NEW YORK STATE DEPARTMENT OF ENVIRONMENTAL CONSERVATION

Re: Sub-slab Depressurization Work Plan
Former Wollensack Optical Site
Site No.: C828209
City of Rochester, Monroe (C)

The New York State Department of Environmental Conservation (Department) and the New York State Department of Health (NYSDOH) (collectively known as the State) have completed their review of the June 18, 2019 Sub-slab Depressurization System Work Plan (Work Plan) for the Former Wollensack Optical site (Site) located at 872 and 886 Hudson Avenue, City of Rochester. Based on the information presented in the Work Plan, the Work Plan is approved with the following modifications and clarifications.

R-100

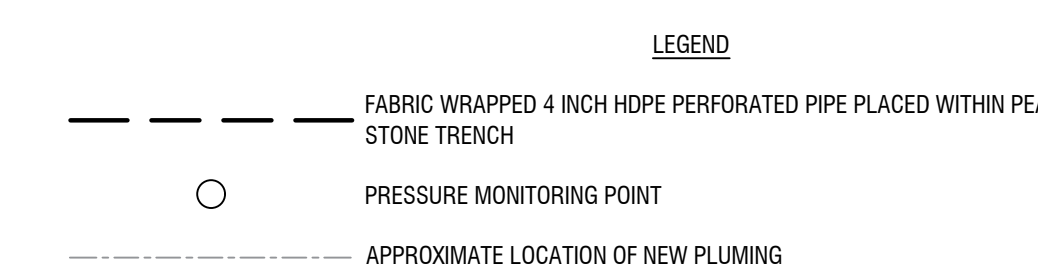
2. In order to ensure the SSDS is mitigating the whole footprint of the Site's existing building additional sampling/monitoring points need to be installed within the building's footprint. The attached figure has been modified to show the proposed locations for the additional sampling/monitoring points.

ADDITIONAL SAMPLING/MONITORING POINTS - APPROXIMATE LOCATIONS.
